# MANDATORY SERVICE BULLETIN

## NO. MSB 42-083

## NO. MSB 42NG-014

Replacement of the passenger door retaining bracket.

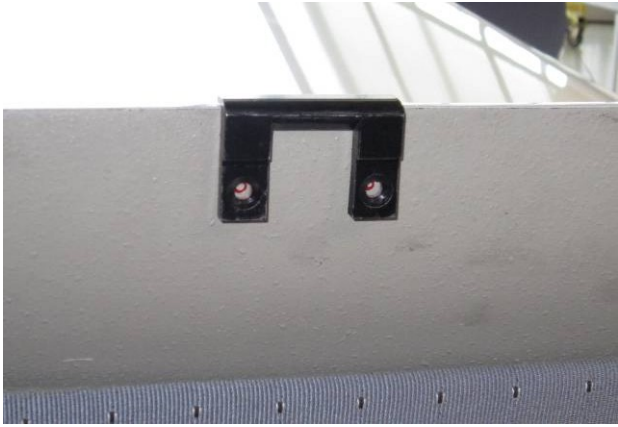
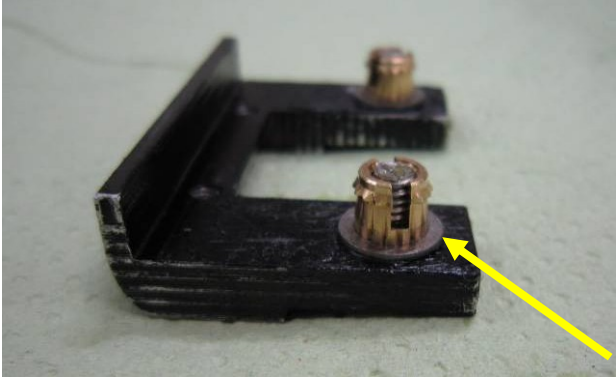
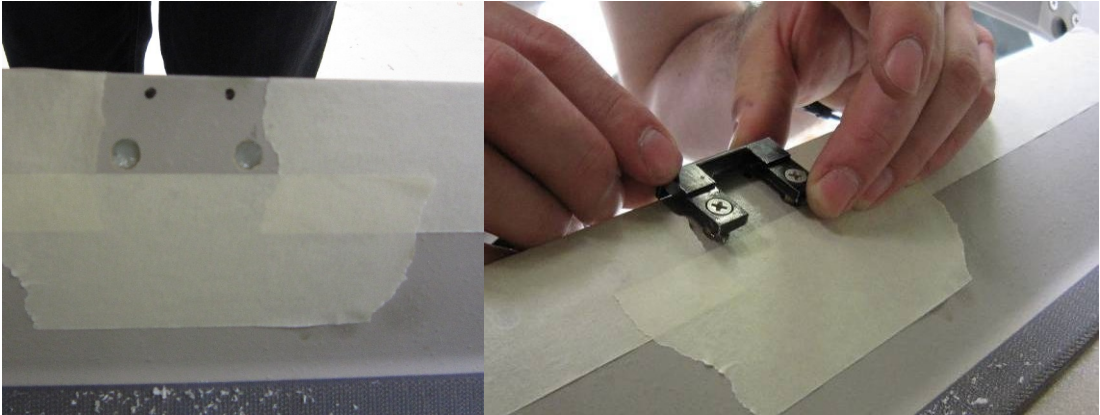
1	<p>If the Retaining Bracket P/N: DA4-5200-00-69_1 is installed (refer to picture), ensure the function acc. to AMM-TR-MÄM-42-334. No further action necessary.</p> <div data-bbox="614 667 1077 840" data-label="Image"></div> <p data-bbox="683 875 997 904">P/N: DA4-5200-00-69_1</p>
---	---

2	<p>Remove the two screws from the fuselage which hold the Retaining Bracket (P/N: DA4-5200-00-69).</p>
3	<p>Install the Retrofit Retaining Bracket (P/N: DA4-5200-00-69-SB) on the old position and mark the position of the two holes from inside the fuselage.</p> <div data-bbox="529 1279 1150 1704" data-label="Image"></div>
4	<p>Remove the Retaining Bracket and drill the two holes with a diameter of 7mm (9/32 inch) and a depth of 7mm (9/32 inch) on the marked positions.</p>

5	<p>Prepare the Retaining Bracket for bonding the thread Insert.          Grease the Retaining Bracket, the screws and the washers.          Clean the thread insert from grease and dirt.</p>  <p style="text-align: right;">Washer DIN 125</p>
6	<p><b>WARNING:</b> When handling chemicals always observe Health and Safety Regulations given by the manufacturer of the chemicals.</p>
7	<p>Fill the holes with the two-part adhesive MA300 and install the Retaining Bracket</p> 
8	<p>Let the installation cure for one hour.</p>
9	<p>Remove the Retaining Bracket and carefully remove the washers DIN 125.</p>
10	<p>Install the Retaining Bracket with screws DIN 963 M3x12-A2-BC and DIN 965-AM4-10-A2.</p>
11	<p>Check function of door locking mechanism refer to AMM-TR-MÄM-40-377.</p>
12	<p>Clean the working area and check for foreign objects.</p>
13	<p>Ensure Temporary Revision AFM-TR-MÄM 42-443 has been incorporated into the Airplane Flight Manual.</p>
